UNITED STATES PATENT AND TRADEMARK OFFICE

APPLICATION NO.	FILING DATE	FIRST NAMED INVENTOR	ATTORNEY DOCKET NO.	CONFIRMATION NO.
10/765,951	01/29/2004	Hubert Bucher	080404.53096US	1846
23911	7590 11/13/2006		EXAMINER	
CROWELL & MORING LLP INTELLECTUAL PROPERTY GROUP P.O. BOX 14300			DEVOTI, PAUL D	
			ART UNIT	PAPER NUMBER
WASHINGT	ON, DC 20044-4300		3637

DETAILED ACTION

Serden (DE 10135266) Figure 3

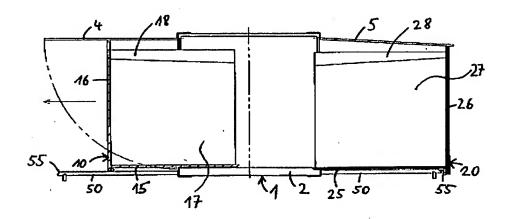
- 1. Claims 1, 2, 4, 8, 13, 15, 16, 19, and 20 are rejected under 35 U.S.C. 102(b) as being anticipated by Serden (DE 10135266).
- 2. Regarding claims 1 and 4, Serden (DE 10135266) discloses a container (1) having a floor wall (2), a roof wall (3), and a foldable side wall (5). An expansion element (20) is movable out of the container (1). The expansion element (20) comprises a floor wall (25), a side open to the container (1), and a front wall (26) opposite the open side. A roof wall is formed from the foldable side wall (5). A lifting device in the form of a winch or hydraulic cylinders lowers the expansion element (20) so that the floors of the expansion element (20) and container (1) are situated at the same level.

- 3. Regarding claim 2, the container (1) comprises an additional side wall and expansion element (10) that is movable out of the container (1) with the lifting device, in an opposite direction from the first expansion element (20). The expansion element (20) is movable into the expansion element (10) as seen in Fig. 2.

- 4. Regarding claim 8, surface elements (28) close gaps between the expansion element (20) and the foldable side wall (5), creating an interior space.

5. Regarding claim 13, a surface element (28) is vertically movable with respect to the side wall (27).

- 6. Regarding claim 15, the surface element (28) is connected to the expansion element (20), and when the expansion element is moved out of the container (1) in a path via the track (50), the surface element (28) is also guided in a path via the track (50).
- 7. Regarding claims 16 and 20, the ends of the surface element (28) inherently seal via contact between the surface element (28) and the expansion element (20) or container (1).
- 8. Regarding claim 19, the surface element (28) is foldable away from the foldable side wall (5) of the container (1).

Stout (US 2167557) Figure 3

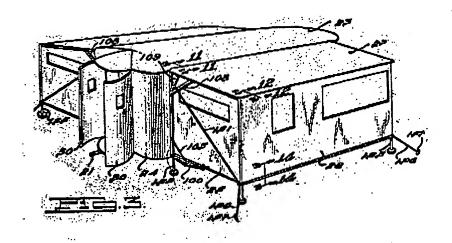
- 9. Claims 1, 3, 4, and 7 are rejected under 35 U.S.C. 102(b) as being anticipated by Stout (US 2167557).
- 10. Regarding claims 1 and 4, Stout discloses a container structure having a floor wall, a roof wall (23), and a foldable side wall (27). An expansion element is movable out of the structure. The expansion element comprises a floor wall (26), a side open to the structure, and a front wall (28) opposite the open side. A roof wall is formed from the foldable side wall (27). A lifting device (a winch device as seen in Fig. 16) lowers the expansion element so that the floors of the expansion element and container structure are situated at the same level.

- 11. Regarding claim 3, tracks (110) are provided on the foldable side wall (27) to guide the expansion element.
- 12. Regarding claim 7, the winch device (in Figure 16) comprises two cables (121 and 136) and helps move the expansion element into position.

- 13. Regarding claims 5 and 6, rollers (111) are attached to the expansion element and inherently act as traveling carriages which are guided in the track (110). As the rollers (111) move in the track (110), they help guide the expansion element out of the structure, which in turn guides the cables.
